NUCLEAR RADIATION CENTER

April 26, 1982

W.S.U. RELICENSE REVIEW QUESTIONS RESPONSE

Figure 3.2-1A

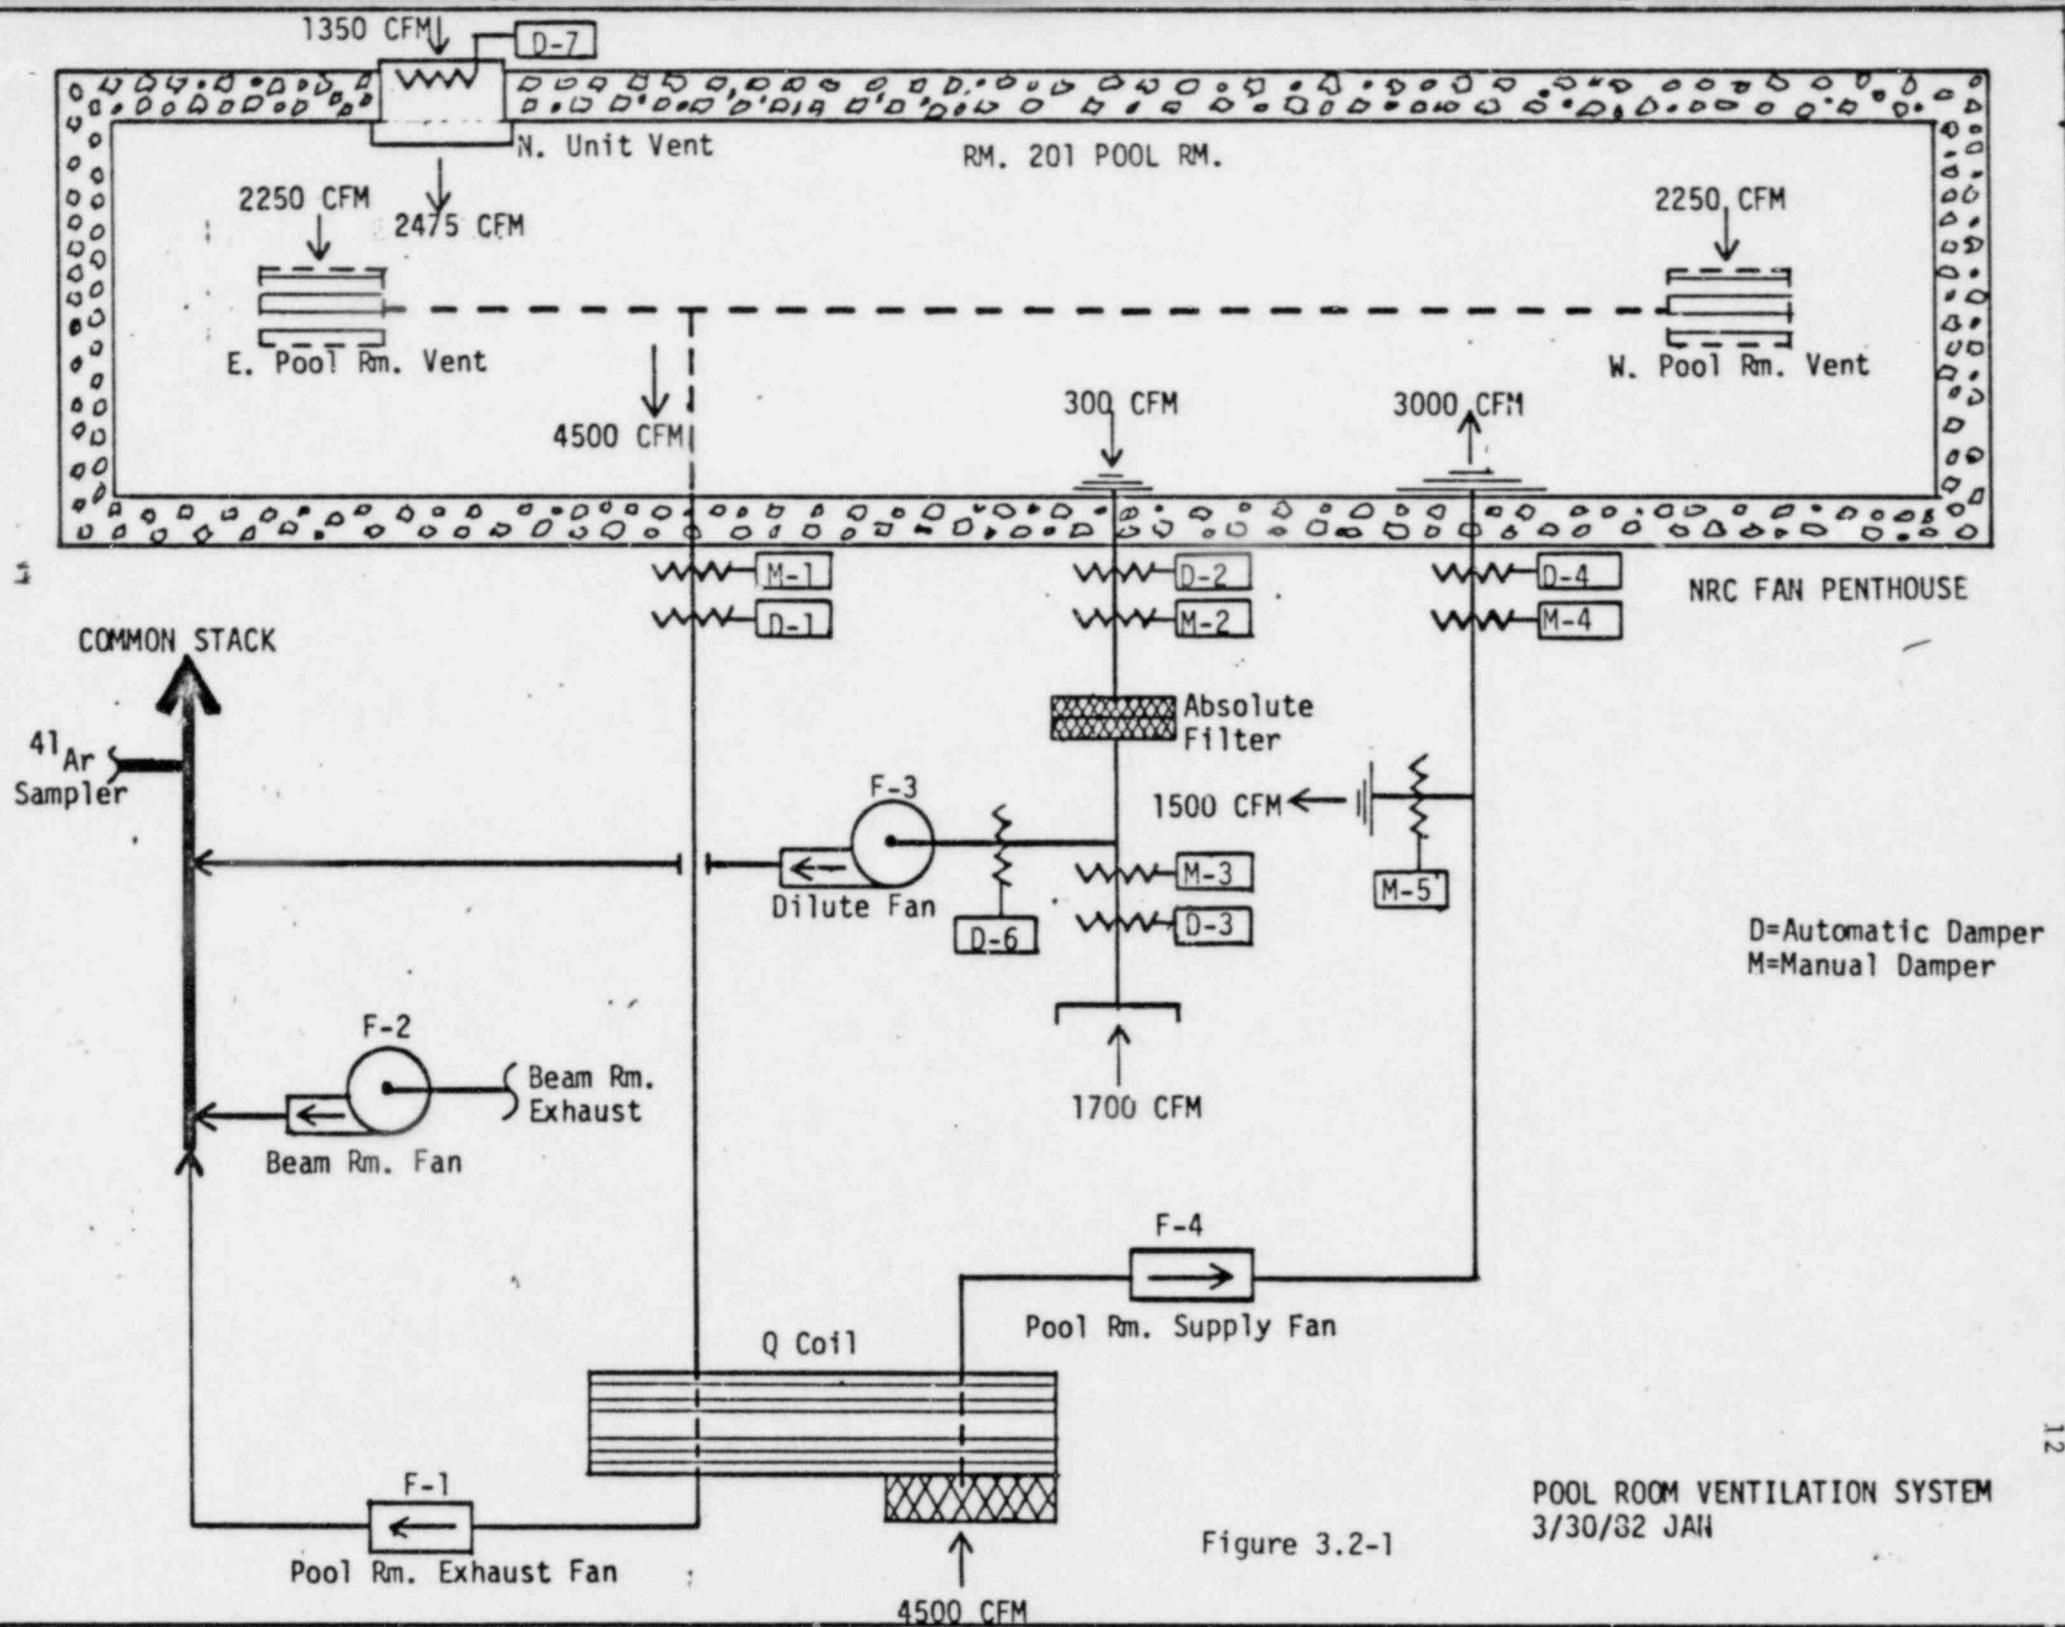
3. Describe the reactor room ventilation system, including filter types and efficiencies. Specify exhaust stack height and location with respect to the balance of the Nuclear Radiation Center Complex.

4. Is the flow rate in the effluent stack monitored? If not, how is the operational status verified?

6. What functional tests are conducted on the ventilation isolation system? How is damper closure verified?

ANSWER: The reactor area ventilation system is shown in the attached drawings 3.2-1 and 3.2-1A from the SAR. A recent modification to the ventilation system increased the exhaust rate from the pool room from 2000 to 4500 CFM during normal operation.

The ventilation system operation modes are shown in Figure 3.2-1A. During normal operation 4500 CFM of air are exhausted from the pool room and discharged up the monitored stack. All the control dampers are spring loaded to shut in the event of a loss of control air pressure or AC power. In the event of a scram, the system automatically shifts to the isolation mode. Return to the normal mode requires the reactor operator to reset the vent system.

In the event of a CAM alarm the vent system shifts to the dilution mode. This mode may also be entered manually by operator intervention. In the dilute mode 300 CFM of air is exhausted from the pool room, passed through an absolute filter, mixed with 1700 CFM of outside air, and then discharged to the atmosphere.

The exhaust stack is located in the central part of the facility roof and extends about 36" above the roof. The absolute filter in the dilution mode line consists of two SGN C1 Caisson Filter boxes and standard C1 24" x 24" x 11-1/2" absolute filters. The Dop test on these filters yields a filter efficiency of 99.97 for .3 micron particles.

ANSWER: The actual flow rate is not measured but each of the four fans shown in Figure 3.2-1, F1 to F4, have paddle type flow switches installed that give a positive indication of the presence or absence of air flow. The flow indicator lights are located in the reactor control room.

ANSWER: The auto-isolate and auto-dilute modes are checked daily before reactor startup. The startup checkoff sheets include a functional test of the ventilation system. The ventilation system control panel in the control room indicates the status of each fan and damper.
